DrawDiff Comparison Report

Part number: UNKNOWN | Job: test1 | Generated: 2026-05-09T04:19:56+00:00

ISO_VIEW_LEFT ■ ORIGINAL | REVISED

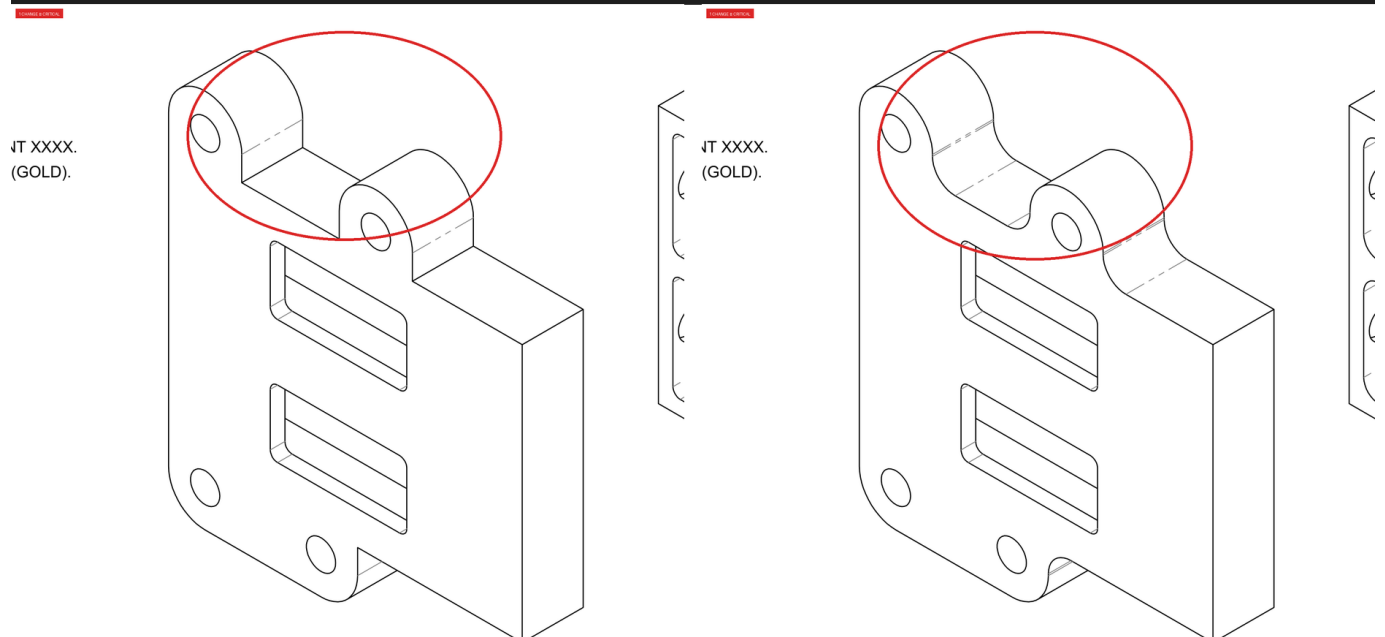
Severity	Field	Zone	Original	Revised	Conf.	Rationale
CRITICAL	geometry	A4	Upper hinge/pivot block has a flat-topped rectangular boss with a sharp step separating it from the curved saddle	Upper hinge/pivot block profile is reshaped: the flat rectangular boss is removed and replaced with a continuous curved/blended profile transitioning smoothly into the saddle	0.82	The upper pivot-block geometry has been fundamentally redesigned from a stepped rectangular protrusion to a smoothly blended curved form, which changes the structural cross-section and load-path of the hinge feature.

ISO_VIEW_RIGHT [MATCHED]

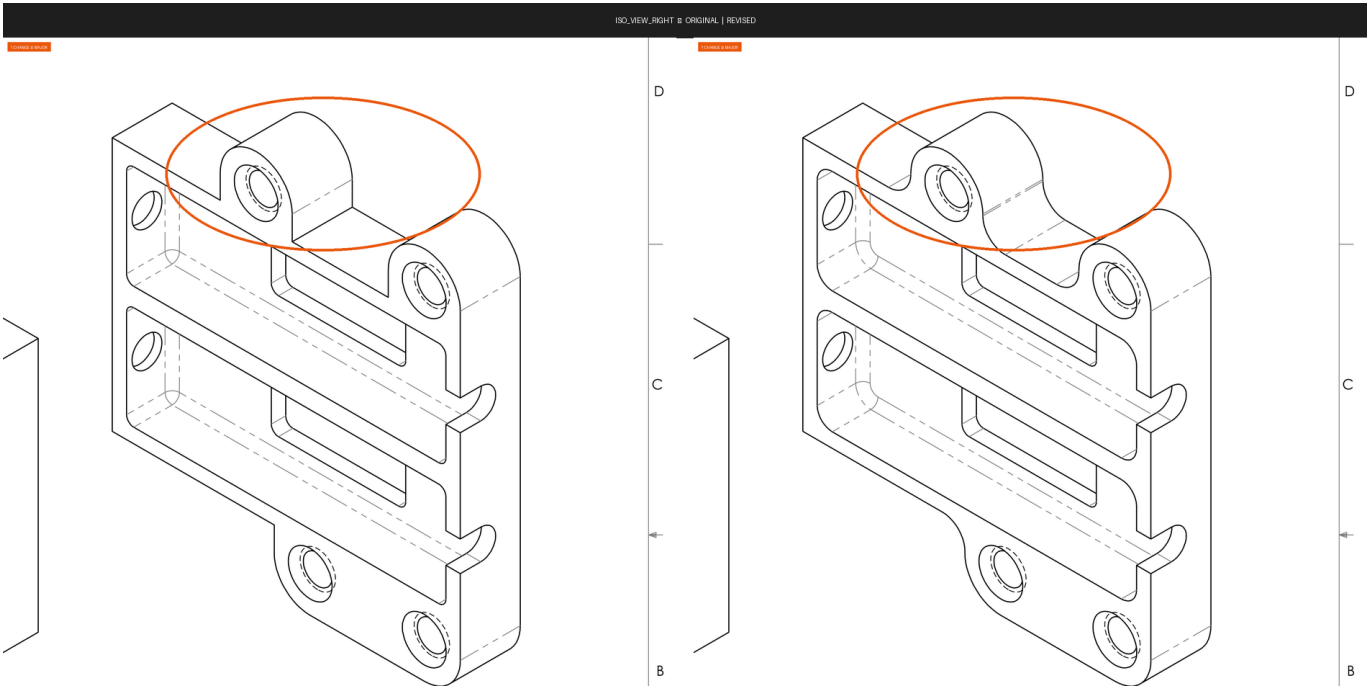
Severity	Field	Zone	Original	Revised	Conf.	Rationale
SIGNIFICANT	geometry	A2	Upper boss/lug area shows two separate cylindrical bosses with a flat top land between them and a visible raised ridge/step between the two boss features	Upper boss/lug area shows a continuous curved saddle profile connecting the two bosses with no flat top land between them — the intermediate flat step is removed and replaced with a concave curved transition	0.82	The upper mounting lug geometry between the two boss features has changed from a flat-topped stepped configuration to a concave/saddle curved profile, indicating a design change to the connecting web or lug shape that affects material volume and potentially strength.

SECTION B-B [MATCHED]

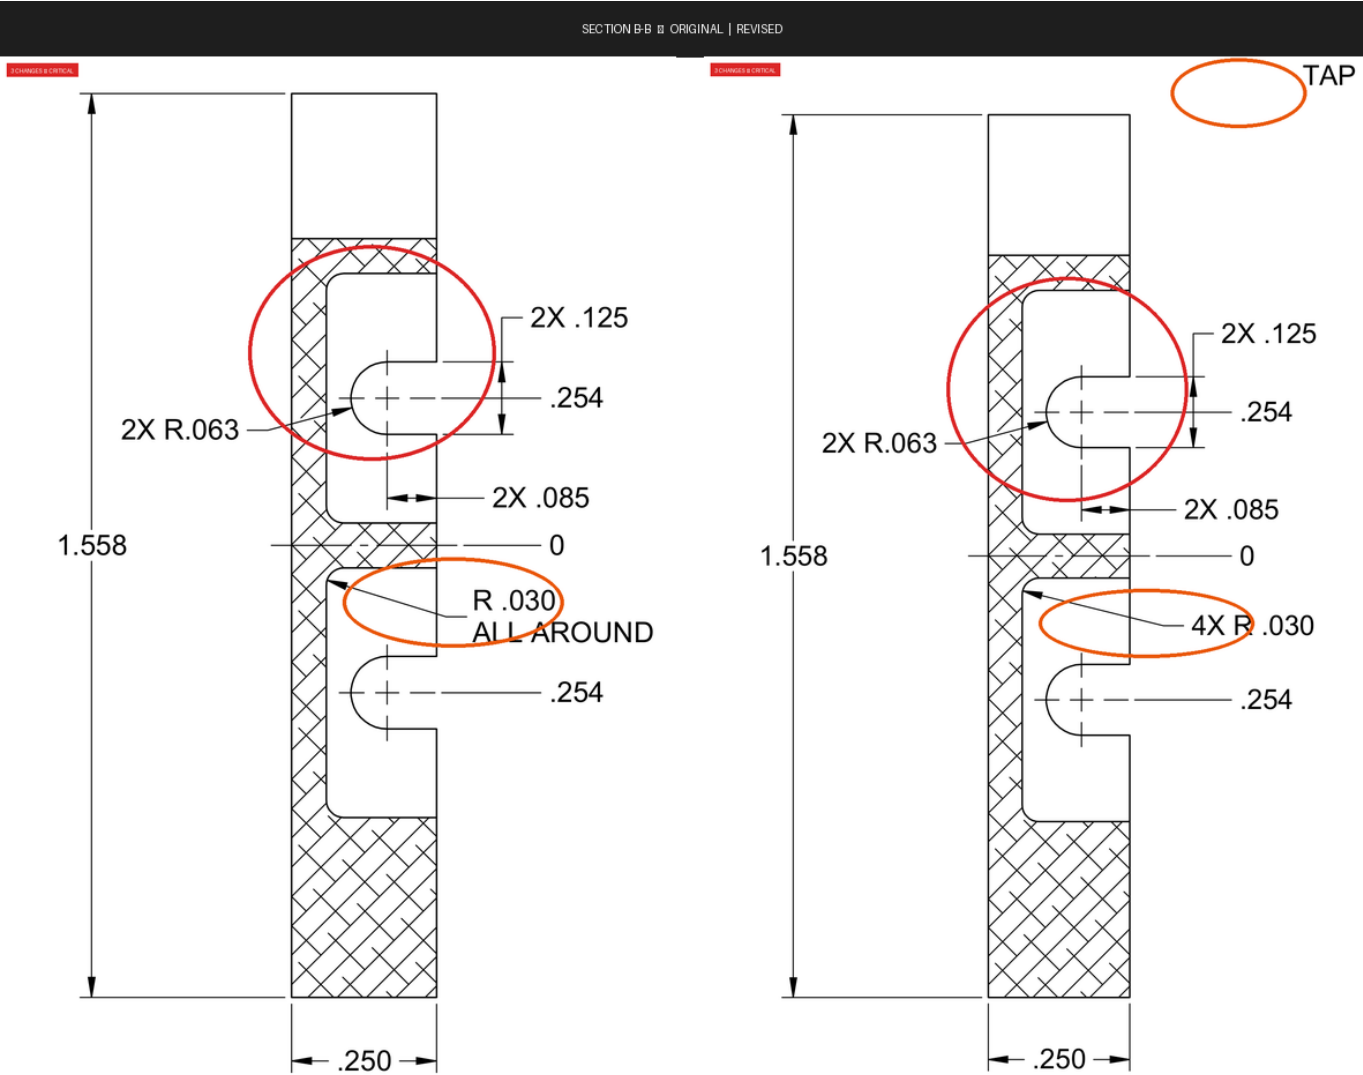
Severity	Field	Zone	Original	Revised	Conf.	Rationale
CRITICAL	geometry	B7	Upper slot with closed rounded top profile (U-shape fully enclosed at top)	Upper slot with open top profile (U-shape open at top wall)	0.78	The upper slot geometry in the revised view appears to show an open-top channel rather than a closed semicircular end, which would significantly change the functional form of the feature.
SIGNIFICANT	annotation	A7	—	TAP	0.95	A new 'TAP' label was added to the revised drawing, indicating a tapping operation is now called out on this view that was not present in the original.
SIGNIFICANT	callout	B7	R .030 ALL AROUND	4X R .030	0.92	The radius callout changed from 'ALL AROUND' to an explicit count '4X', which changes the scope specification of the fillet radii and affects how many features are controlled.

FRONT_VIEW [MATCHED]

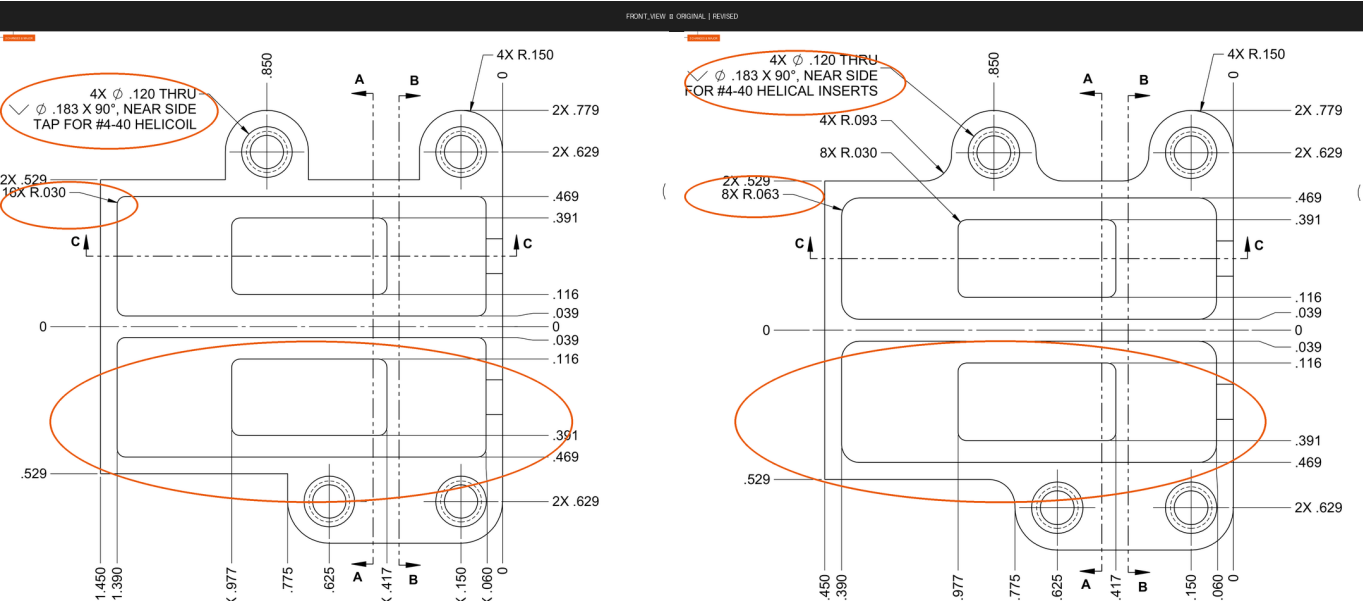
Severity	Field	Zone	Original	Revised	Conf.	Rationale
SIGNIFICANT	note	A6	TAP FOR #4-40 HELICOIL	FOR #4-40 HELICAL INSERTS	0.92	The thread insert callout text changed from 'TAP FOR #4-40 HELICOIL' to 'FOR #4-40 HELICAL INSERTS', which alters the manufacturing instruction and insert specification terminology.
SIGNIFICANT	annotation	A6	16X R.030	8X R.063	0.90	The corner radius callout on the main body changed from 16X R.030 to 8X R.063, indicating both the radius size and the count of these radii have changed, affecting part geometry.
SIGNIFICANT	geometry	B4	Lower pocket has rounded corners on inner rectangular recess	Lower pocket inner recess appears to have sharper/different corner treatment	0.70	The lower half of the part shows a visible geometry change in the inner pocket corner radii treatment between original and revised views, consistent with the radius callout changes.

SECTION A-A [MATCHED]

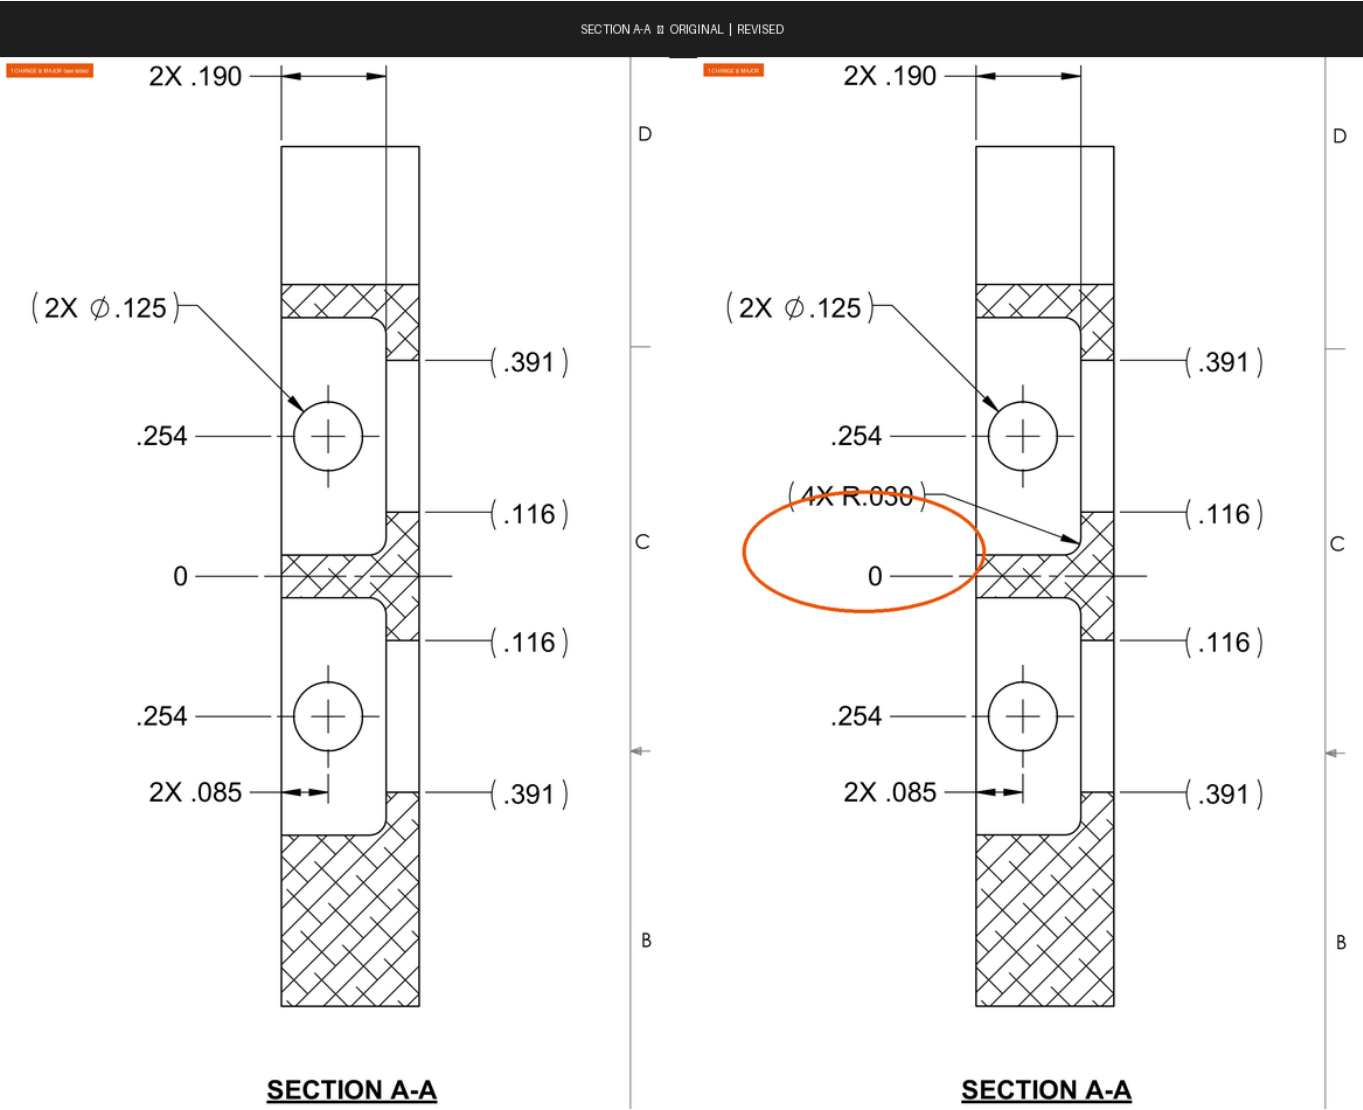
Severity	Field	Zone	Original	Revised	Conf.	Rationale
SIGNIFICANT	callout	B2	—	(4X R.030)	0.95	A new reference callout '(4X R.030)' has been added in the revised drawing, indicating four corner radii of 0.030 on the slot/pocket feature, which is a new manufacturing requirement not present in the original.

SECTION C-C [MATCHED]

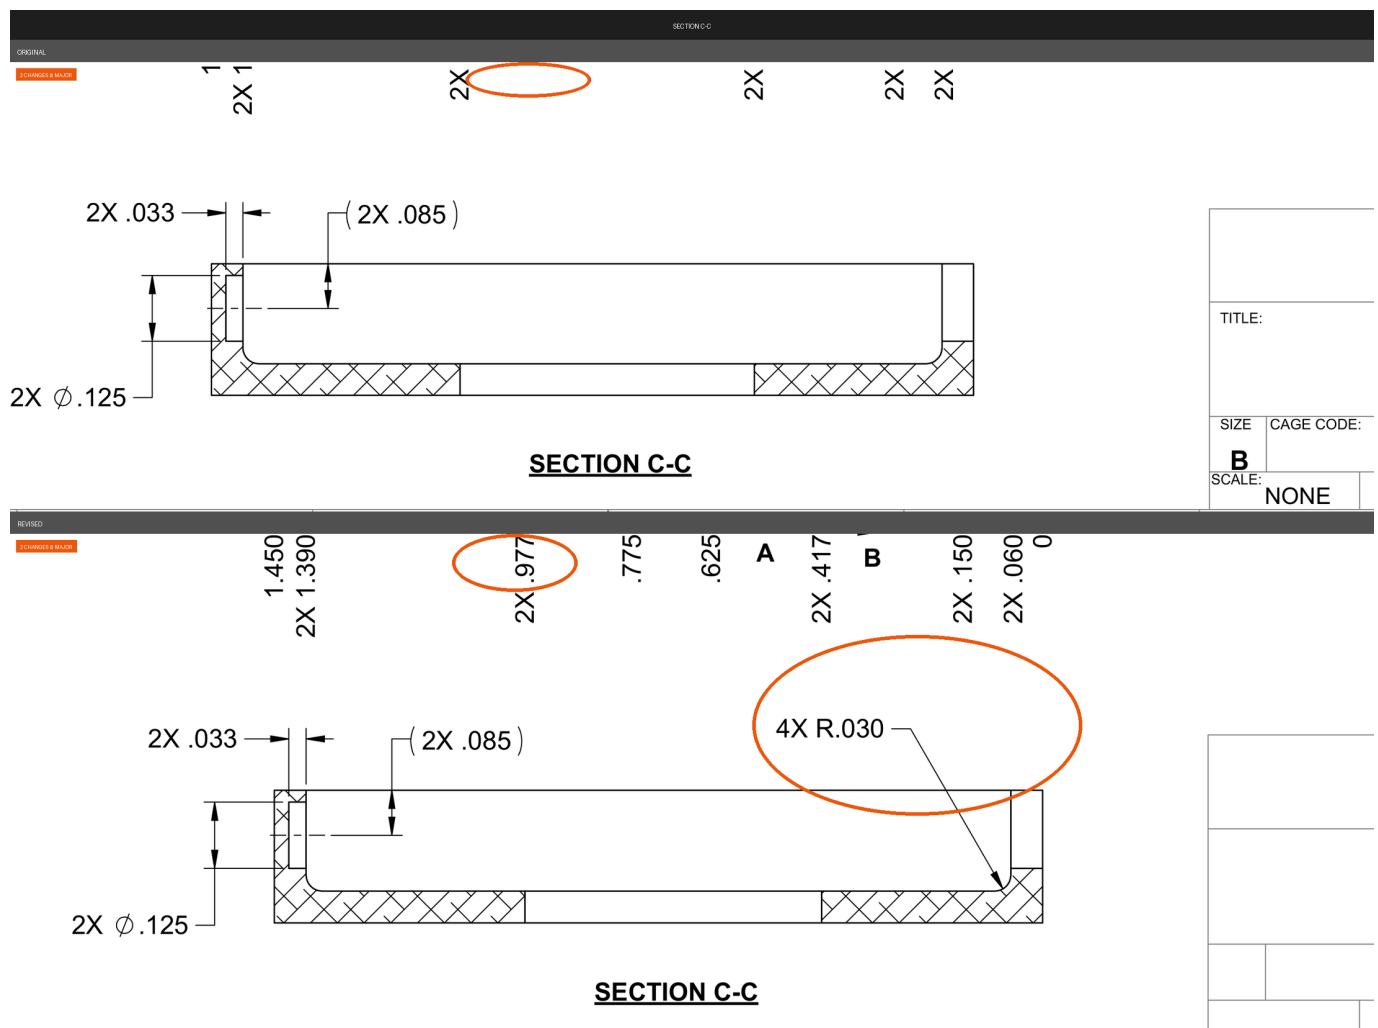
Severity	Field	Zone	Original	Revised	Conf.	Rationale
SIGNIFICANT	annotation	D4	—	4X R.030	0.92	A new radius callout '4X R.030' has been added in the revised drawing pointing to the corner radii of the channel section, specifying four corners with a 0.030 radius that was not previously called out.
SIGNIFICANT	dimension	C5	2X (truncated, no numeric value visible)	2X .977	0.80	The second dimension annotation at the top of the view now shows an explicit value of '2X .977' in the revised drawing where only a truncated '2X' label was visible in the original.
